Utah Lake Drainage Basin
Water Delivery System
Bonneville Unit, Central Utah Project

Final Environmental Impact Statement

Errata for:

Surface Water Hydrology Technical Report

Figure 2-1
Utah Lake Distribution Plan
Monthly System Storage Conversion Line

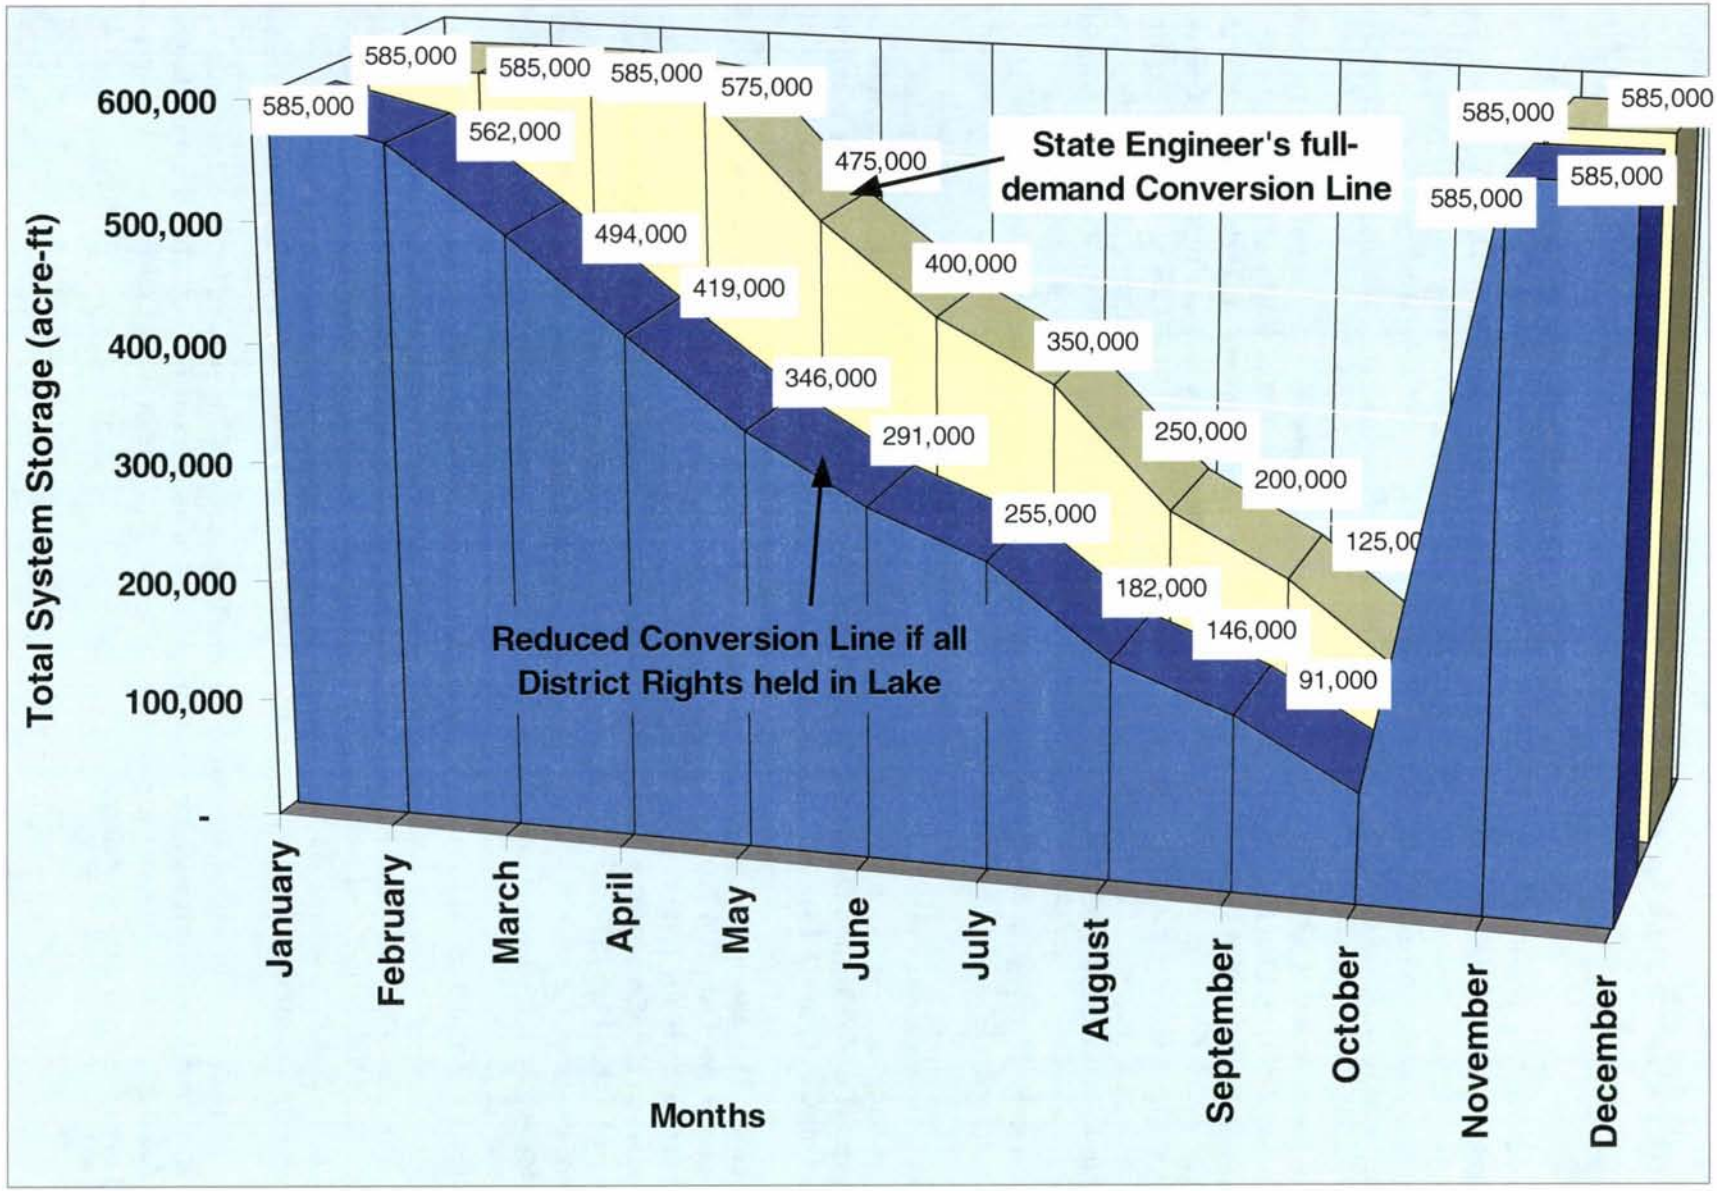
conversion line shown on Figure ~~21~~ **2-1** represents a lower operational level in Utah Lake under which conversion of system storage in Jordanelle and/or Deer Creek Reservoirs would be possible. Under the ~~Preferred Alternative~~ **Proposed Action**, DOI would acquire some of the District's secondary water rights in Utah Lake, which as explained above would be exchanged to Jordanelle Reservoir, thereby reducing the amount of replacement water from Strawberry Reservoir needed for the Jordanelle exchange. As a result, this additional quantity of CUP M&I water from Strawberry Reservoir would now be conveyed and delivered directly through ULS facilities to municipal users.

Volume 1, Section 2.1.1, insert Figure 2-1 to follow page 15:
